PETITION FOR SPECIAL HEARING

RE: PETITION FOR SPECIAL HEARING : BEFORE THE ZONING COMMISSIONER
SW corner of York Rd. and : OF BALTIMORE COUNTY
Aylesbury Rd., 8th District
YORK RIDGELY JOINT VENTURE, : Case No. 80-226-SPH
Petitioner

BALTIMORE COUNTY ZONING PLANS ADVISORY COMMITTEE

Re: Item #76 (1979-1980)
Property Owner: York Ridgely Joint Venture
S/W cor. York Rd. and Aylesbury Rd.
Existing Zoning: M.R.-I.M. & M.L.-I.M.
Proposed Zoning: Special Hearing to approve a modified development plan as approved in Case No. 76-259 SPH (Item No. 237, 1975-1976)
Acres: 6.971 District: 8th

PHASE I BLDG ADDITION ELEVATIONS	
PHASE I BUILDING	
RIDGLEY OFFICE PARK	
1830 YORK RD	
TIMONIUM MARYLAND	
SCALE: 1/8" = 1'-0"	DATE: MAY 16 '79
DRWG NO.	A-4

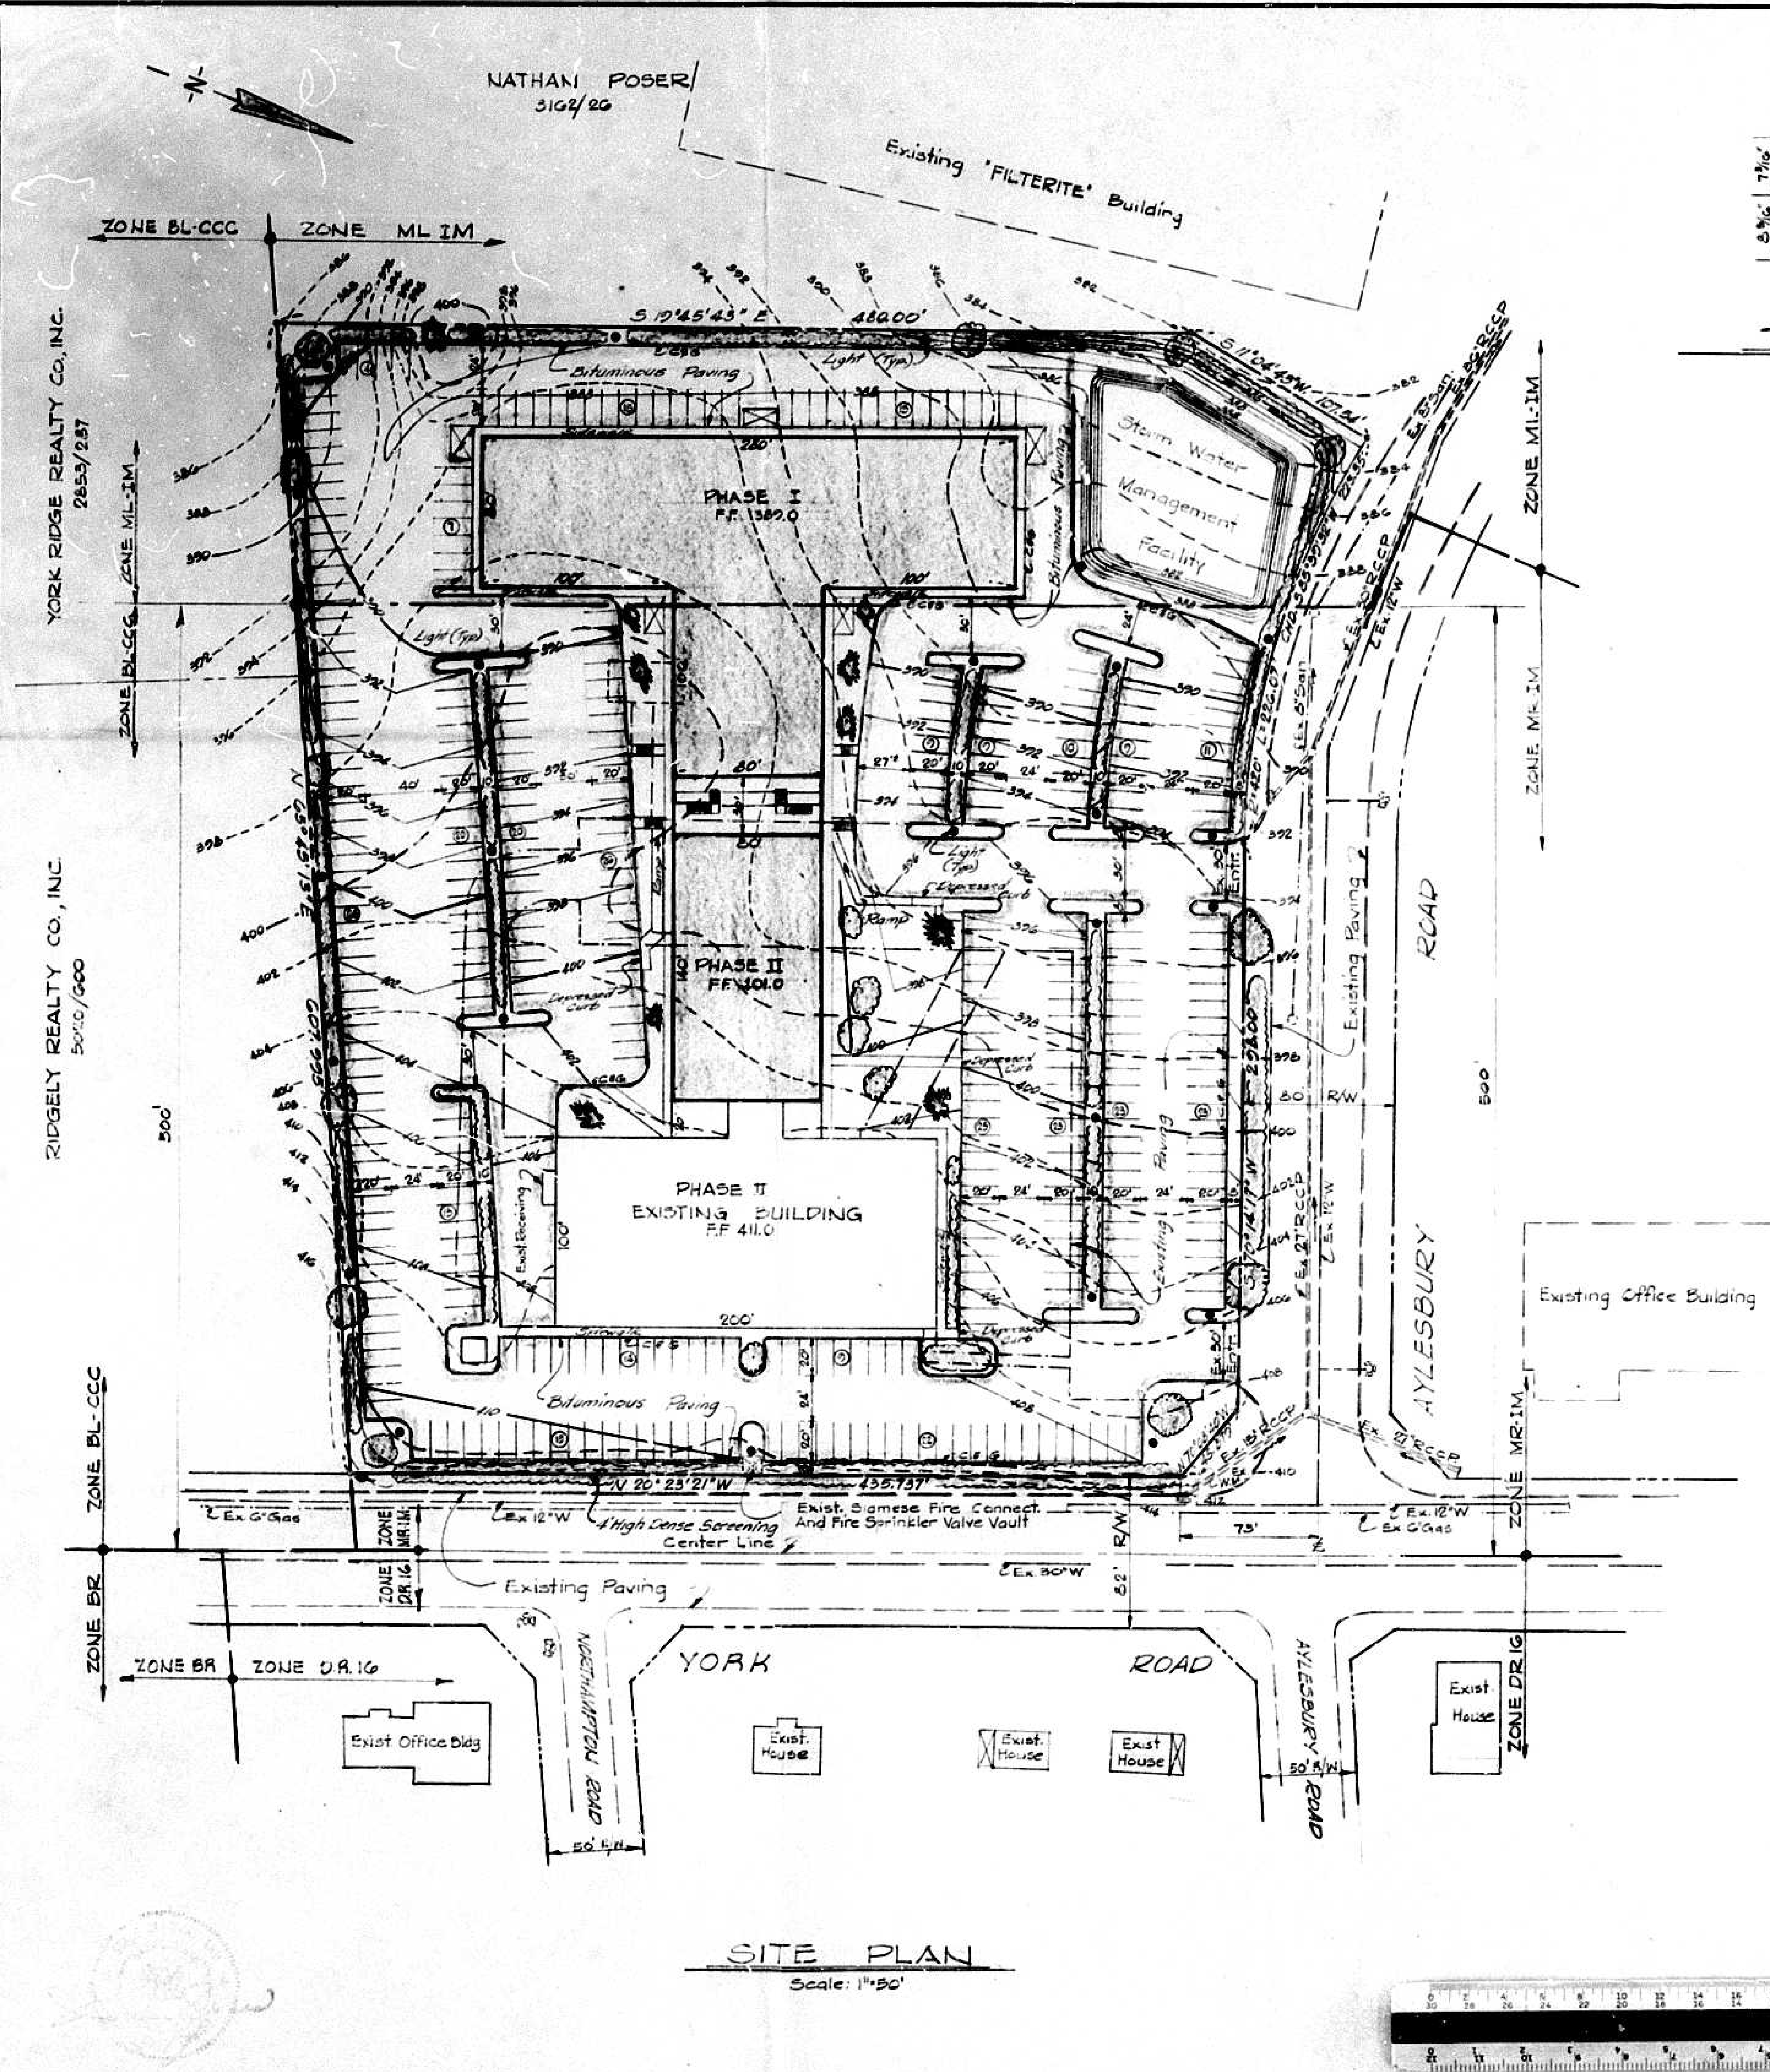
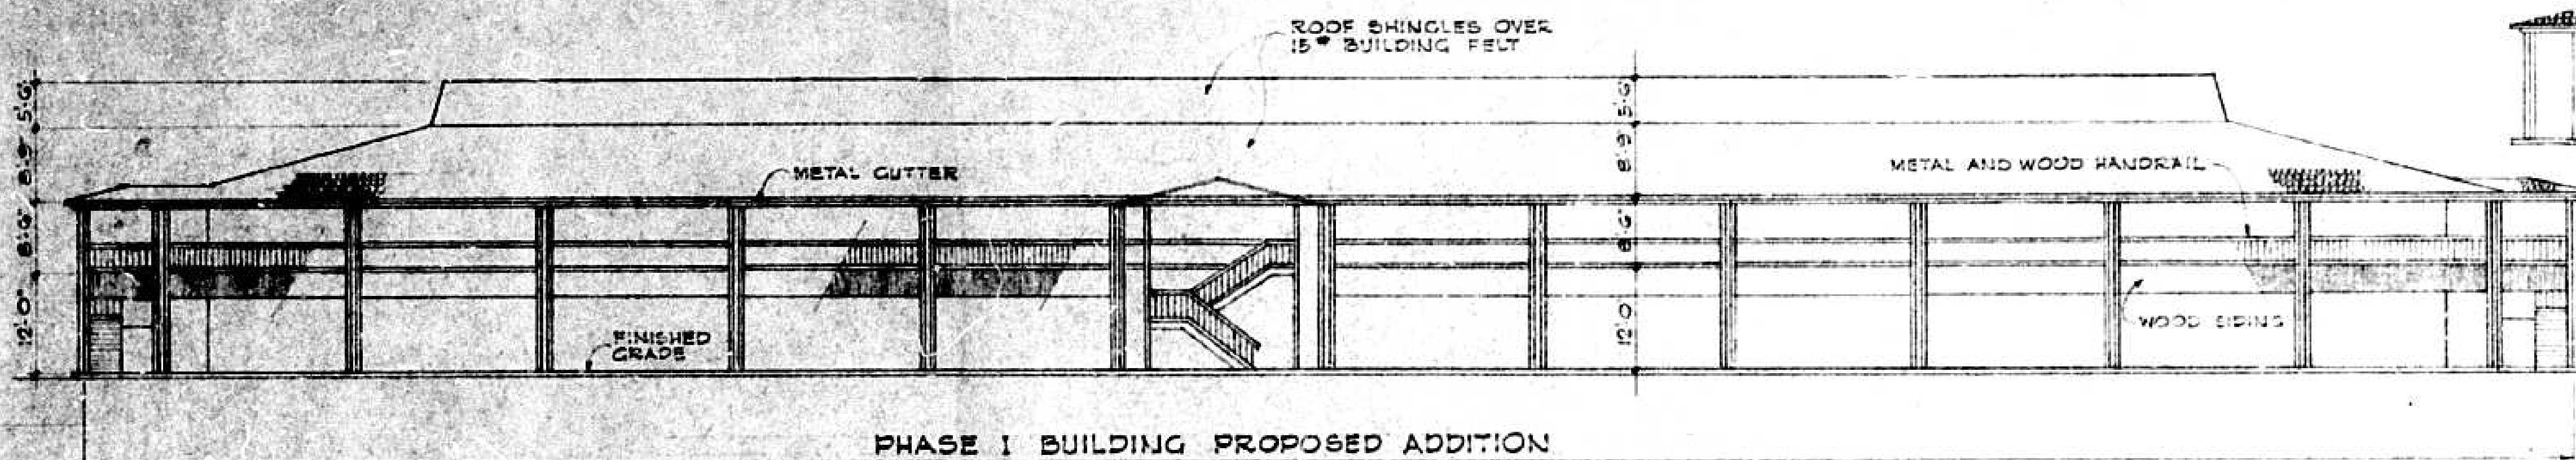
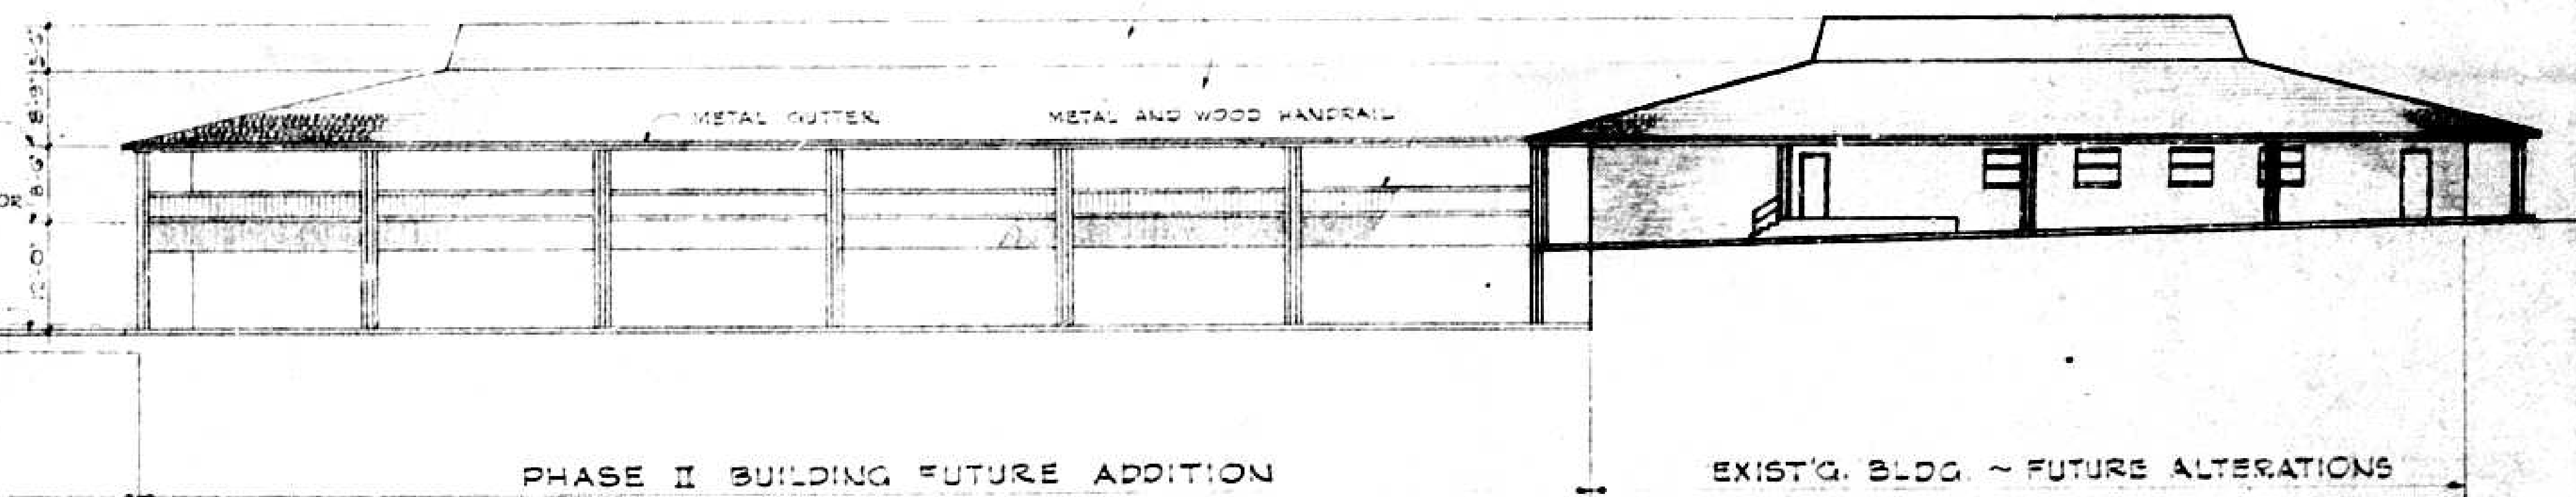
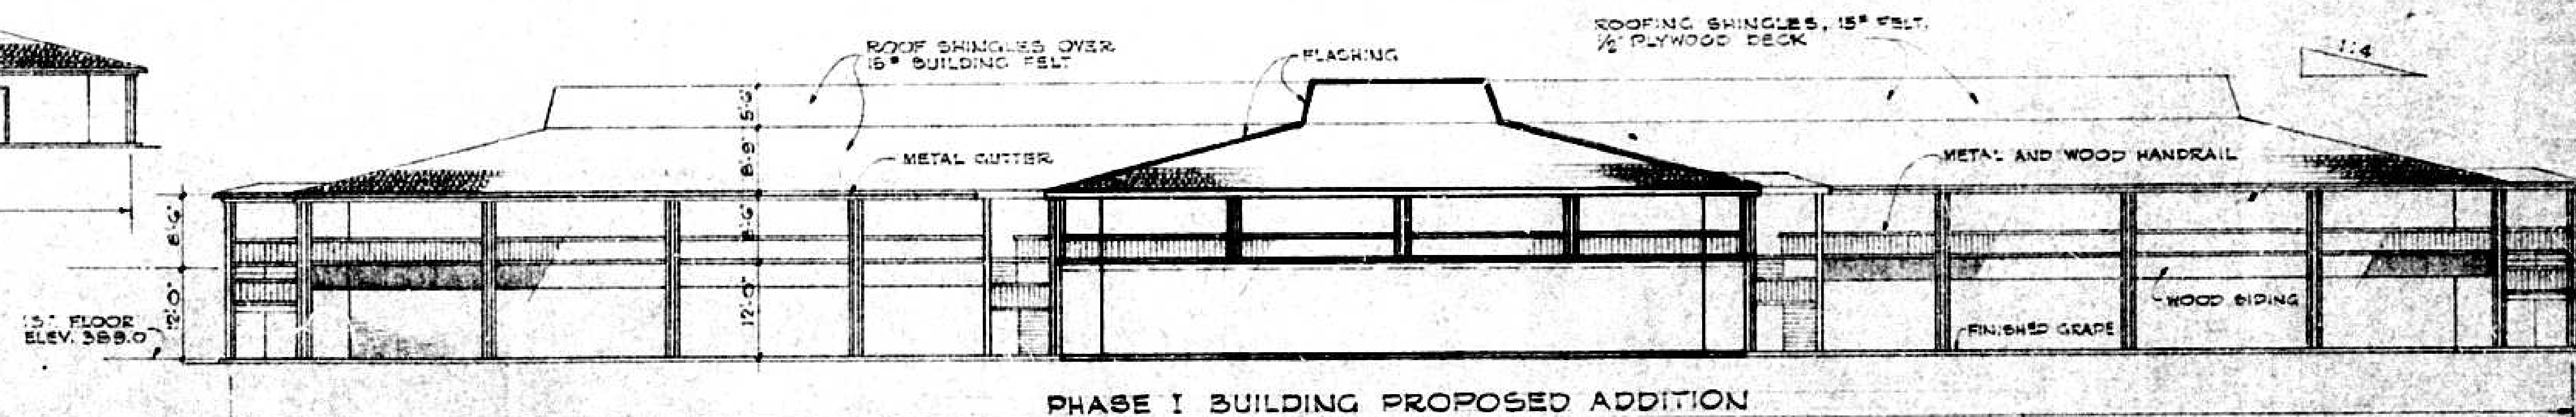
J. Comment- There is no guarantee the building as shown by architect
drawing A-4 will comply with the type of construction
allowed by Tables 5 and 6. If wood shingles are proposed
they will not be acceptable to Section 928.3 of the Building
Code. If the 30'-0" is proposed as fire separation (which may
be required) no construction will be allowed within that 30'-0"
distance. The building appears too large to be one structure
unless it is of Type 1A or 1B construction. Wood is not
permitted for most uses in these classifications.
